Appendix 3 – EIA Scoping

ENVIRONMENTAL IMPACT ASSESSMENT (SCOTLAND) REGULATIONS 2017 SCOPING OPINION

Reference Number: PSC/2021/0005

Location: Land At Pier Road, Ben Lomond Way And Old Luss Road, Known As West Riverside And Woodbank House (Lomond Banks) Balloch

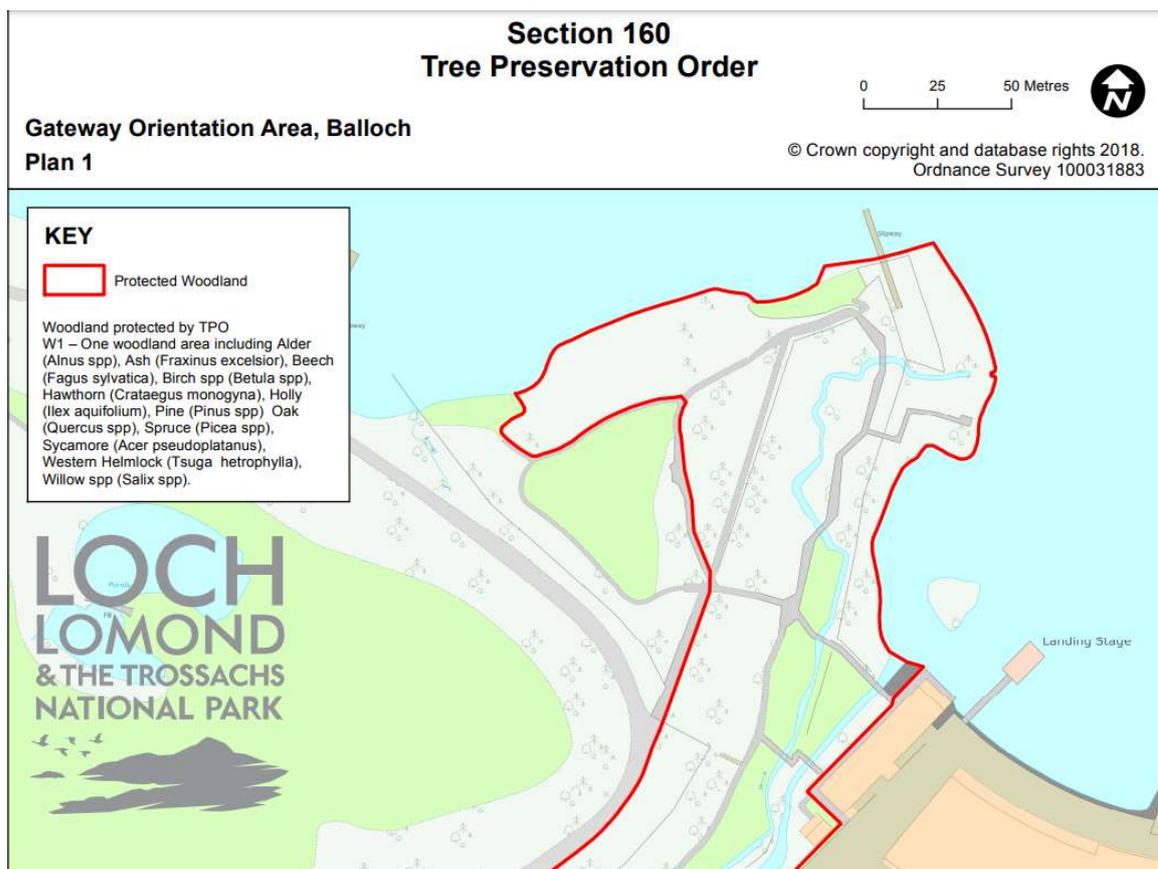
- 4.11. The Loch Lomond and The Trossachs National Park Authority Tree Preservation Order No. 10 (2018) does include a section of the area within the EIA assessment area (see below image). This principally relates to the area of lochshore in the north west of the site.
